MODIFICATIONS

McAllen 10th Floor Jury Assembly Room

NOTE TO A/V INSTALLATION BIDDERS:

SHEET 1.

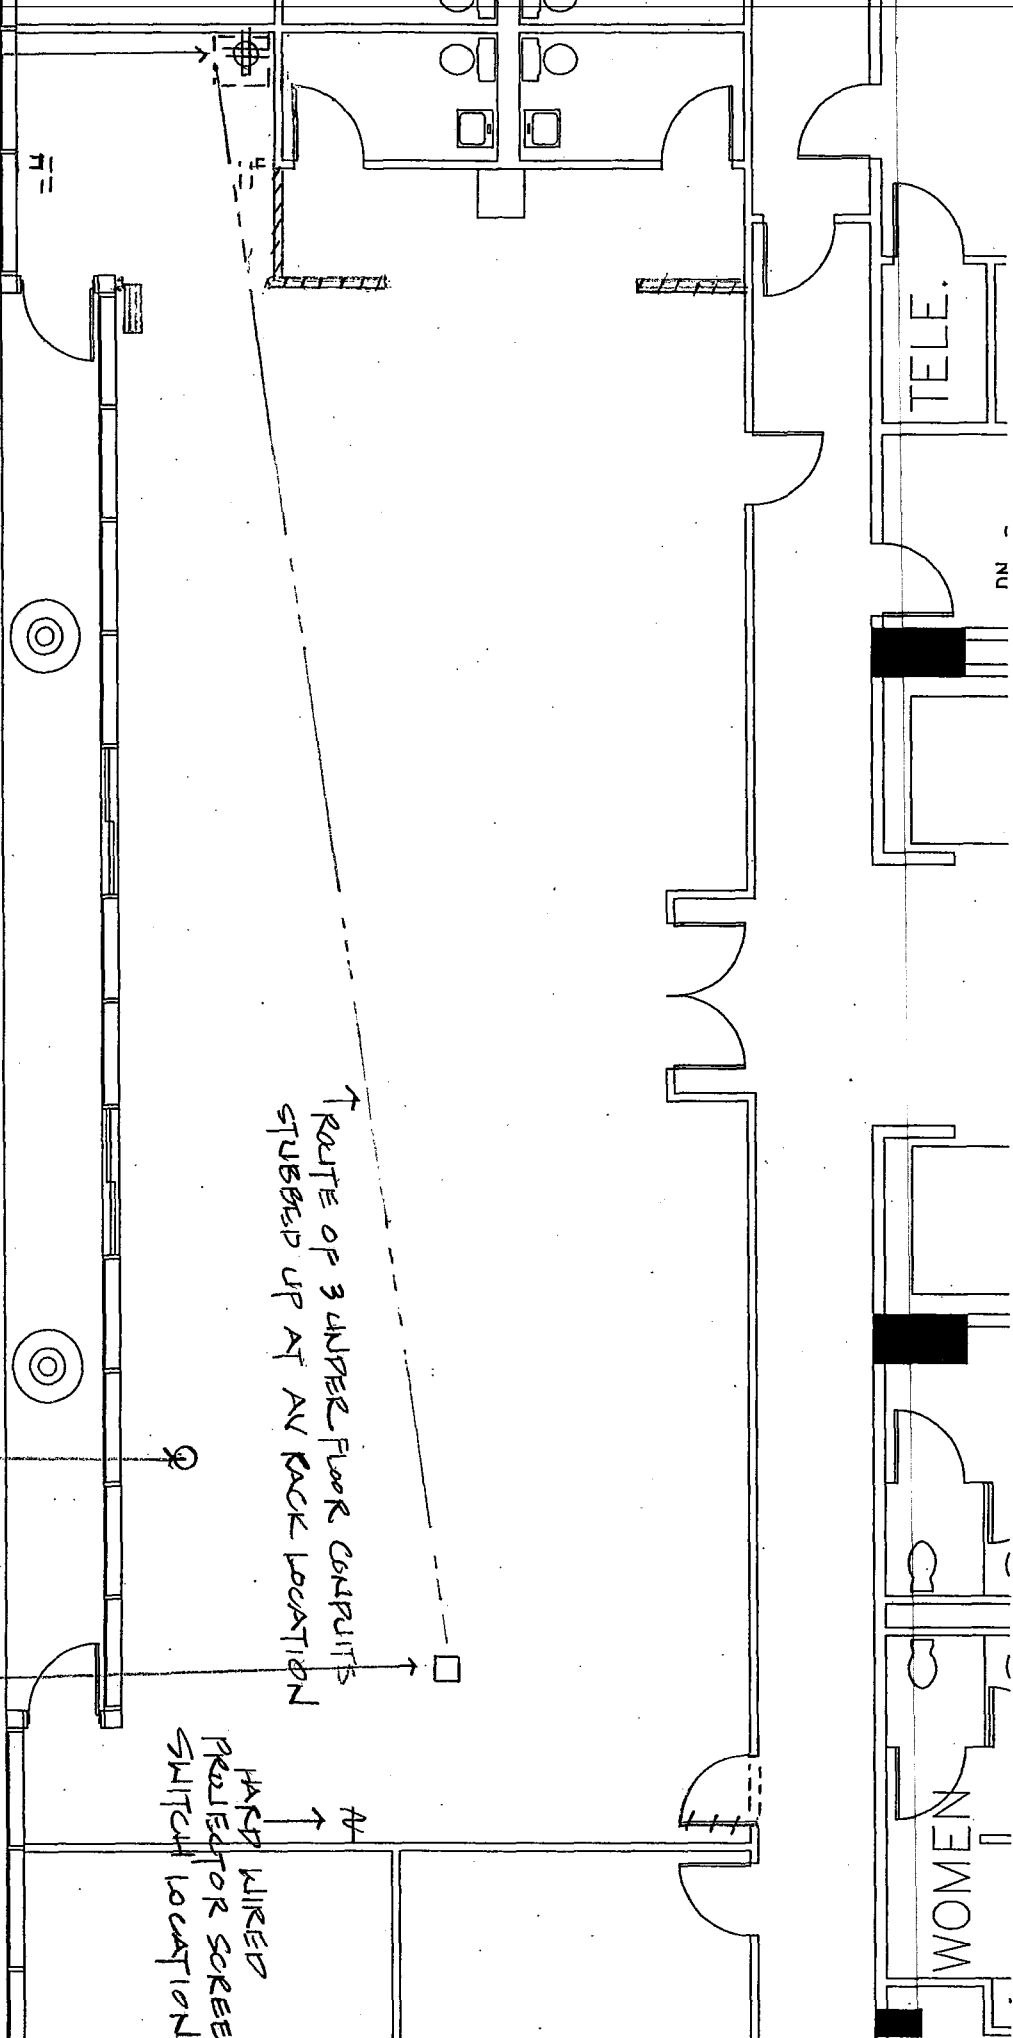
1.) Wall and door changes shall be building standard door and partition systems with the top track to, but not through the existing ceiling grid. Should existing carpet be determined to remain, floor track may be placed on carpet. However, where necessary, existing carpet shall be cleaned and stretched. New walls shall be painted to match existing walls in both color and sheen.

CONSTRUCTION PL.

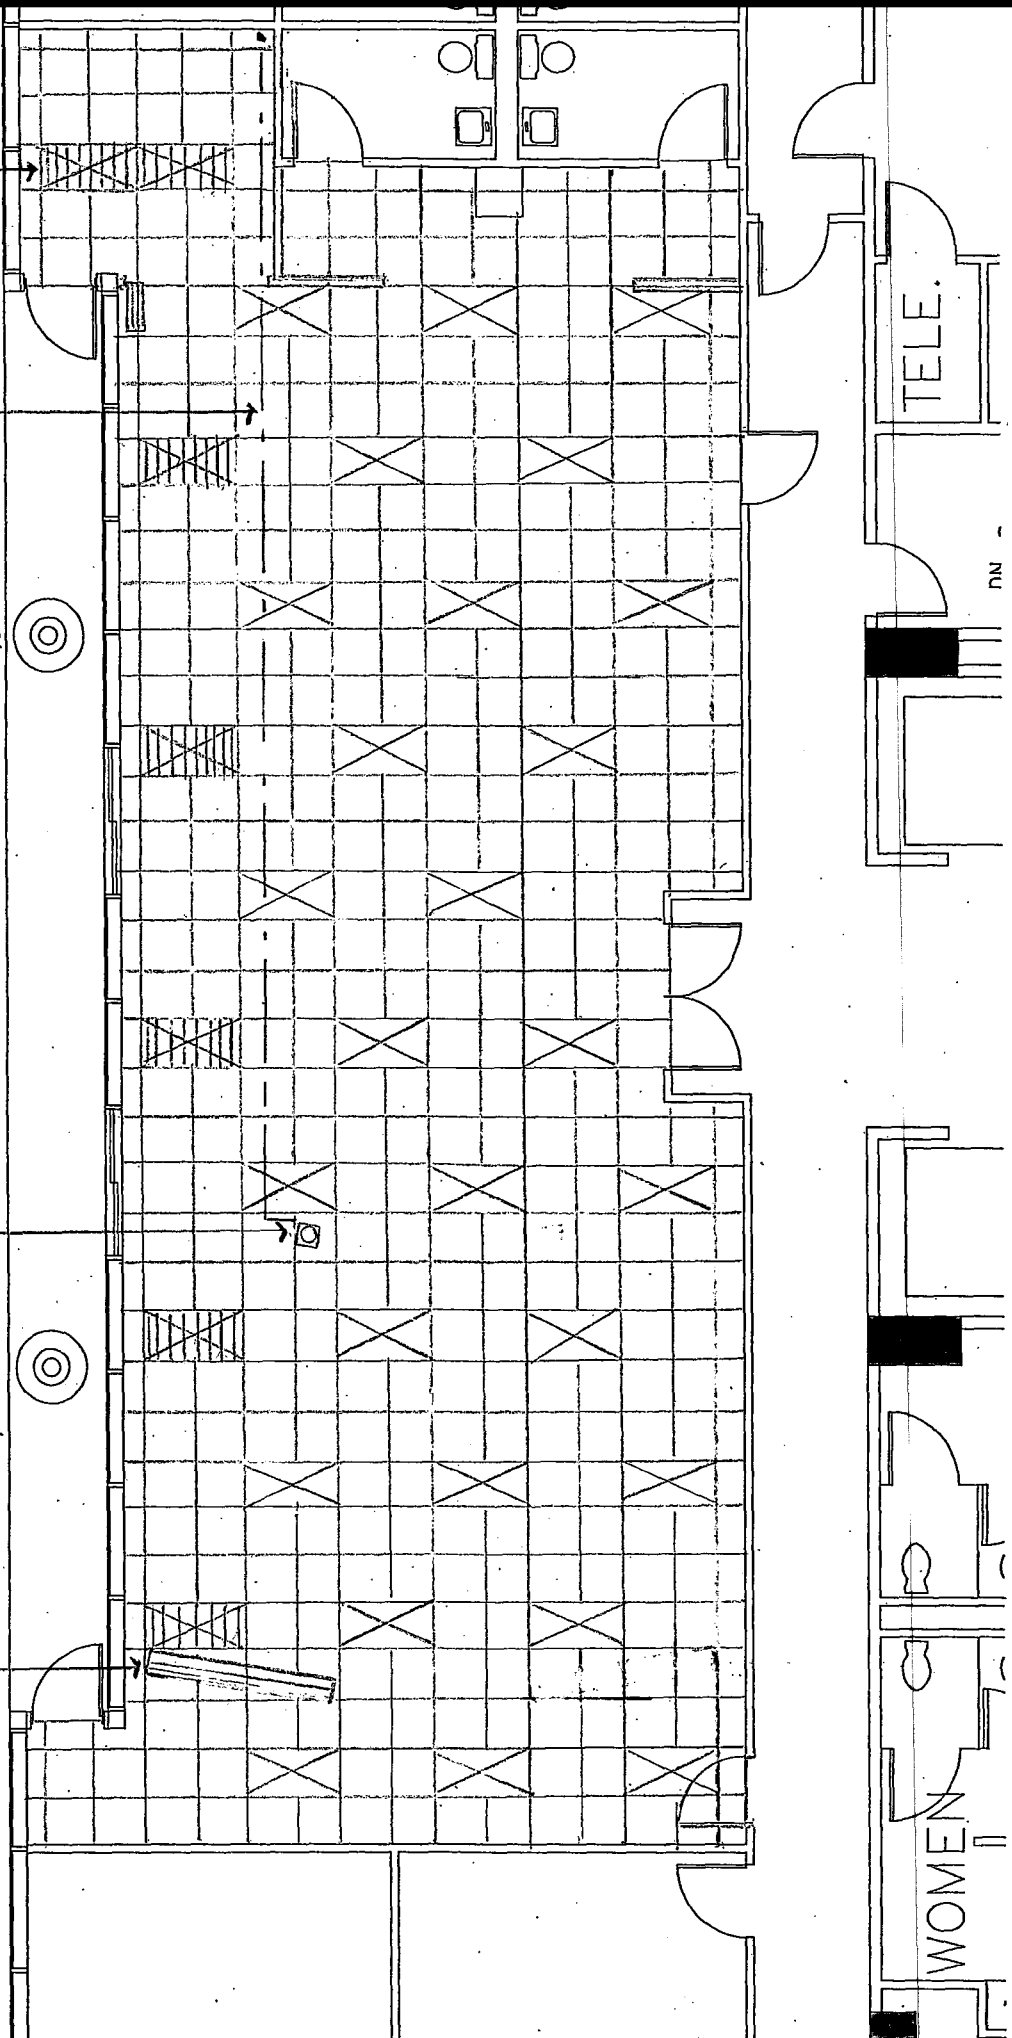
REPLICATED AND
ELECTRICAL FOR AV RACK

ROUTE OF 1-3/4" RENUM CONTROL STUDDED ROW IN @ AV RACK LOCATION

PROPOSED REFLECTED CEILING PL.

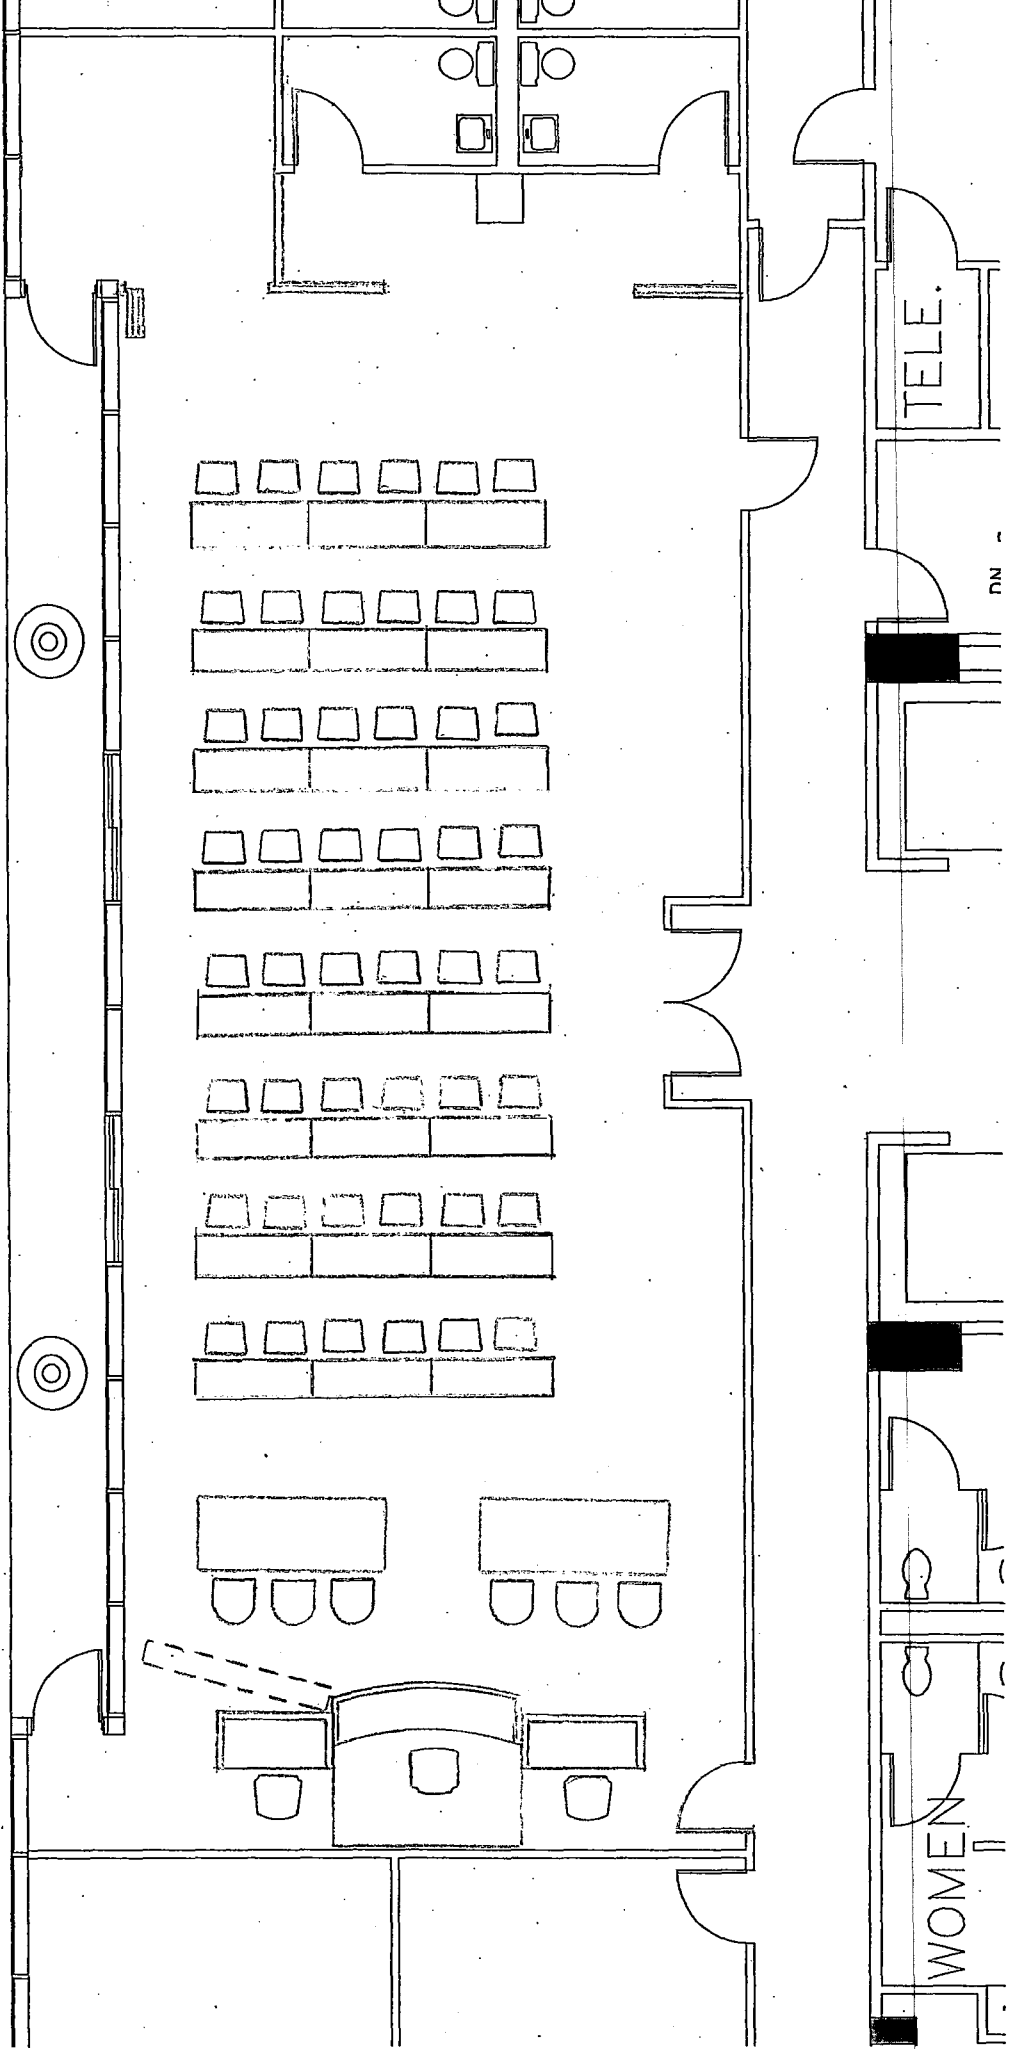
2.) The proposed reflected ceiling plan indicates those 2' x 4' existing fluorescent fixtures running parallel to the window wall to be repositioned in alignment with all other ceiling fixtures (shown 'hatched' on the attached reflected ceiling plan). However, should the site review reveal substantive M and/or P revisions required to affect this change, contractor shall so note and eliminate this requirement from his proposal. NOTE: Should lights remain as they are, there may be a conflict with the positioning of the projector screen and that light will then be eliminated. Should lights be repositioned, that fixture in front of the projector screen must be separately switched from a point on the front wall and directly adjacent to the manual projector control switch.

4.) Contractor shall provide and install one (1) Da-Lite Advantage Deluxe Electrol HDTV (16:9) Format, Matte White 45" x 80" - 92" diagonal projection screen (Da-Lite SKU:88147), or equal where shown on the reflected ceiling plan. Contractor to ensure that a low voltage interface is provided with screen. Provide one (1) duplex electric outlet in plenum above for power supply, one (1) hard wired three position control switch at front wall where shown, and one (1) 3/4" plenum conduit with pull string from projector screen source and stubbing out above A/V rack at rear of room for low voltage interface by others.

5.) Contractor shall provide and install one (1) standard 1-1/2" pipe secured to structure and include 2" threading at pipe end painted black below ceiling line, where shown on the

reflected ceiling plan. (centered on screen and positioned 18' behind screen). Provide one (1) duplex electric outlet in plenum above for power supply, and one (1) 3/4" conduit with pull string from projector source and stubbing out above A/V rack at rear of room for projector interface by others.

PROJECTOR/ MOUNTING BAR LOCATION

PROJECTOR SCREEN LOCATION

RELOCATED FIXTURES - TYP.
